**SAN ANTONIO WATER SYSTEM PURCHASING DEPARTMENT**

Issued By: **D. Anthony Rubin**  
BID NO.: **16-16036**

**FORMAL INVITATION FOR BIDS FOR THE PURCHASE OF THREE (3) MECHANICALLY  
CLEANED BAR SCREENS WITH MULTIPLE RAKE BLADES AND ONE (1) SCREENINGS  
WASHER COMPACTOR FOR SALADO CREEK WRC – ADDENDUM 1**

This **Addendum 1** is issued to make changes as documented herein to the original bid sent to you on April 5, 2016. All other requirements, terms and conditions of the original bid remain the same.

**ATTACHMENT A Photo 6 REVISED – Existing Washer Compactor**

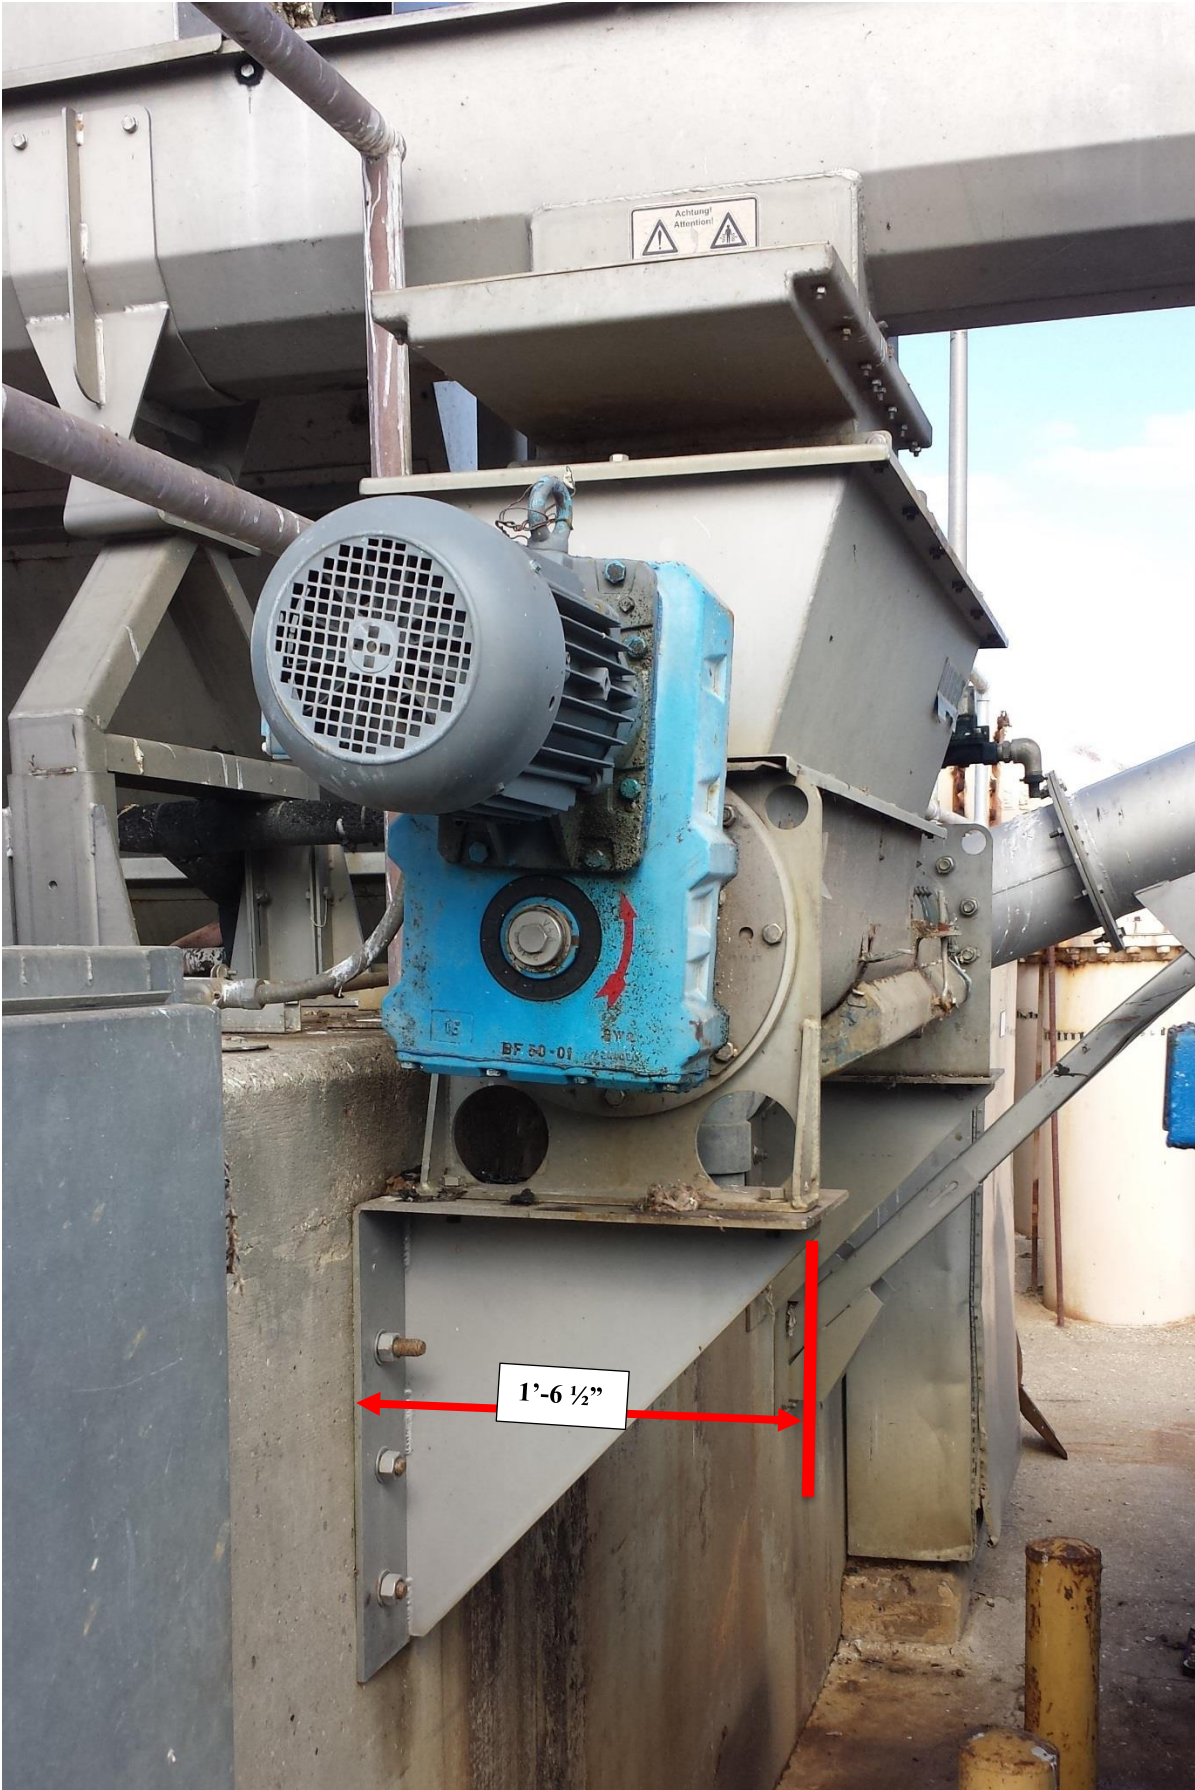
**Under Attachment A, Photo 6, on Page 42 of 49-** See revised Existing Washer/Compactor attachment with support dimensions, see Attachment A Photo 6 Revised.

**Figure 2— Existing Washer Compactor - As-Built Shop Drawings**

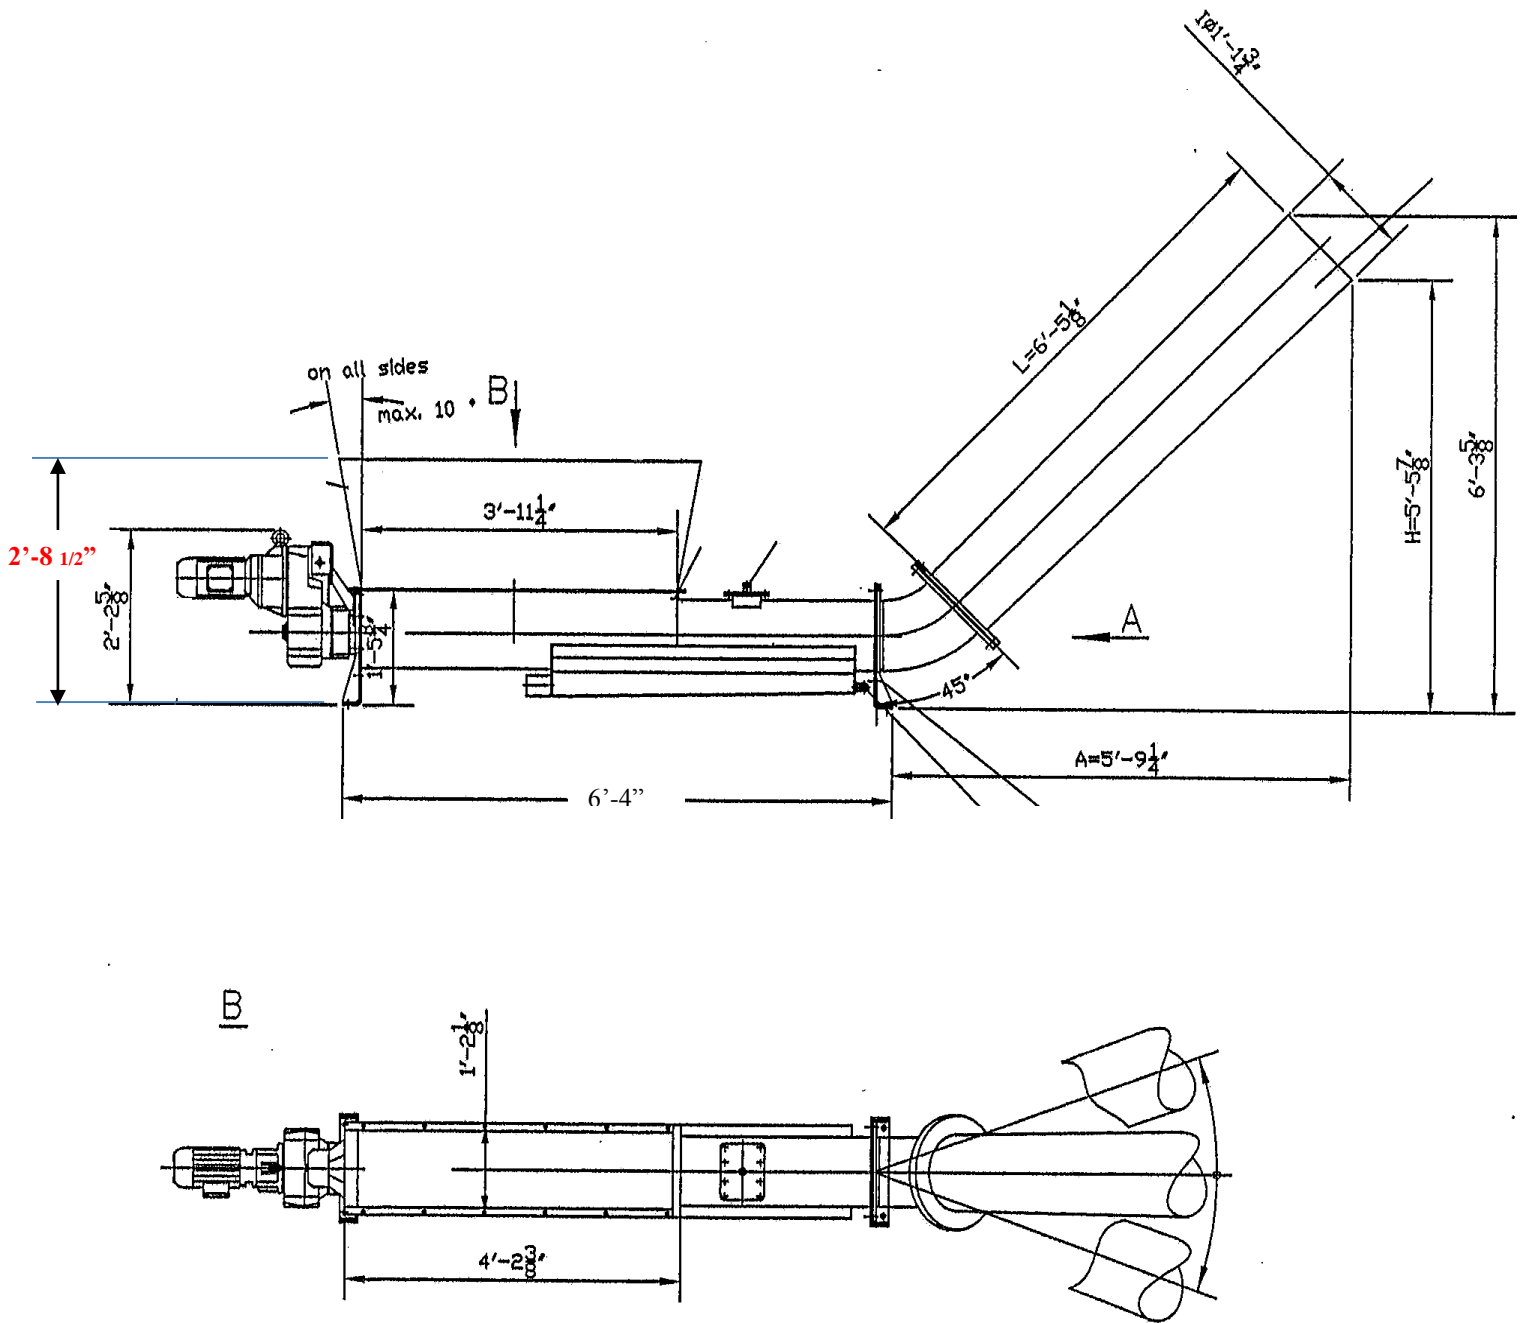
**Under Attachment B, Figure 2, on Page 46 of 49-** See revised existing Washer/Compactor height dimension on attached revised Attachment B, Figure 2, Revised.
